# UNITED STATES PATENT AND TRADEMARK OFFICE

APPLICATION NO.	FILING DATE	FIRST NAMED INVENTOR	ATTORNEY DOCKET NO.	CONFIRMATION NO.
10/759,825	01/20/2004	James M. Tyson	T 1	8027

**Office Action Summary**

## DETAILED ACTION

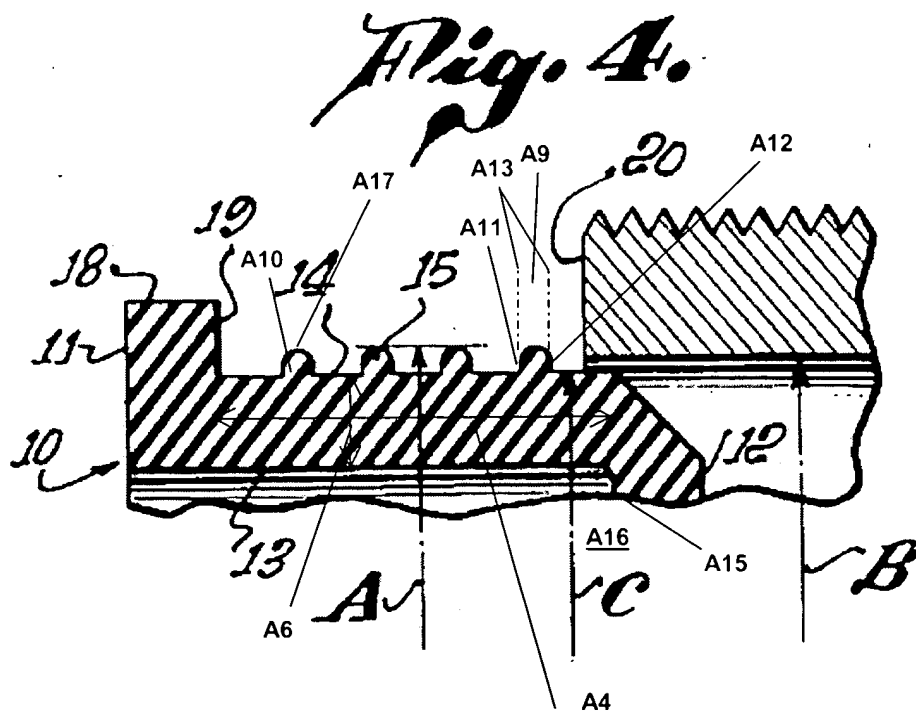
Regarding claim 1, Stringfield discloses, in Figure 1 and 4, an integral resilient plug comprising a main body portion **13**, shoulders **15**, and an end cap **12**. The main body portion **13** has a longitudinal axis **A2** and sides **14** having each an equal length **A4**, an width and an thickness **A6** (col. 5, lines 28-33 states that instead of circular, the plug can be made square). The sides **14** are joined to each other at right angles. The shoulders **15** are of uniform thickness **A9** protruding from the main body portion **13**. The shoulders **15** are spaced from each other along the longitudinal axis **A2**. Each of the shoulders **15** have a segment **A10** integral with one of the sides **14** of the main body portion **13**. Each segment **A10** has a continuous upper flat surface **A11** and a continuous lower flat surface **A12**. The upper flat surface **A11** and the lower flat surface **A12** extend perpendicularly from the sides **14** of the main body portion **13** in parallel planes **A13** that are perpendicular to the longitudinal axis **A2**. The end cap **12** has a flat inner surface **A15** integral with the main body portion **13** that closes one end **A16** of the main body portion **13**. Applicant should not that the plug is able to move in a direction perpendicular to the longitudinal axis and parallel to the planes of the flat surfaces of the segments into engagement with one fence component.

Regarding claim 2, the shoulders **15** are spaced from each other at substantially equal distances along the longitudinal axis **A2** of the main body portion **13**.

Regarding claim 3, each segment **A10** of the shoulders **15** are joined to each other at a right angle at each of their ends so that each shoulder continuously circumscribes the main body portion **13**.

Regarding claim 4, the upper flat surface **A11** and the lower flat surface **A12** have outer edges **A17** that terminate at equal (the same) distances from the sides **14** of the main body portion **13**.

Regarding claim 5, the shoulders **15** are spaced from each other at substantially equal distances along the longitudinal axis **A2** of the main body portion **13**. Each segment **A10** of the shoulders **15** are joined to each other at a right angle at each of their ends so that each shoulder continuously circumscribes the main body portion **13**. The upper flat surface **A11** and the lower flat surface **A12** have outer edges **A17** that terminate at equal (the same) distances from the sides **14** of the main body portion **13**.

GB-1551855

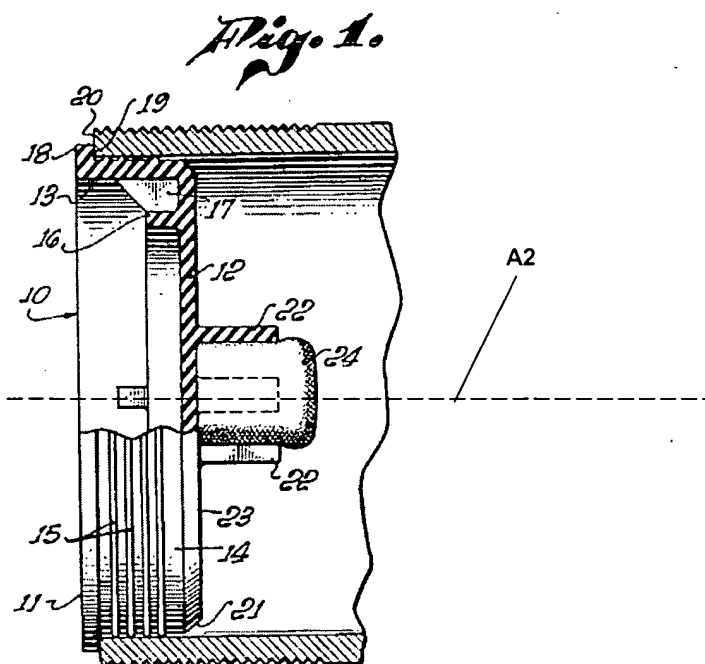
Regarding claim 1, British patent discloses, in Figure 1 and 2, an integral resilient plug comprising a main body portion **16**, shoulders **21-22**, and an end cap **17**. The main body portion **16** has a longitudinal axis **A2** and sides **12-15** having each an equal length, an width and an thickness **A6**. The sides **12-15** are joined to each other at right angles. The shoulders **21-22** are of uniform thickness **A9** protruding from the main body portion **16**. The shoulders **21-22** are spaced from each other along the longitudinal axis **A2**. Each of the shoulders **21-22** have a segment **A10** integral with one of the sides **12-15** of the main body portion **16**. Each segment **A10** has a continuous upper flat surface **24** and a continuous lower flat surface **25**. The end cap **17** has a flat inner surface **A15** integral with the main body portion **16** that closes one end **A16** of the main body portion **16**. Applicant should not that the plug is able to move in a direction perpendicular to the longitudinal axis and parallel to the planes of the flat surfaces of the segments into engagement with one fence component. However, the upper flat surface **24** and the lower flat surface **25** of the segment do not extend perpendicularly from the sides **12-15** of the main body portion **16** in parallel planes that are perpendicular to the longitudinal axis **A2**. Sanderson et al. teach, in Figure 8, An upper flat surface and a lower flat surface of a segment **51A-51C** extending perpendicularly from sides of a main body portion **4** in parallel planes that are

Regarding claim 6, the main body portion **16** is hollow with one end **A16** closed by the end cap **17** and an opposite end **A18** is open to the atmosphere. The end cap **17** has outer peripheral edges **A19** that extend past the main body portion **16** beyond a distance that outer edges **A20** of the upper flat surface **24** and the lower flat surface **25** protrude beyond the sides **12-15** of the main body portion **16**. The flat inner surface **A15** of the end cap **17** is parallel to the planes of the upper flat surface **24** and the lower flat surface **25**.
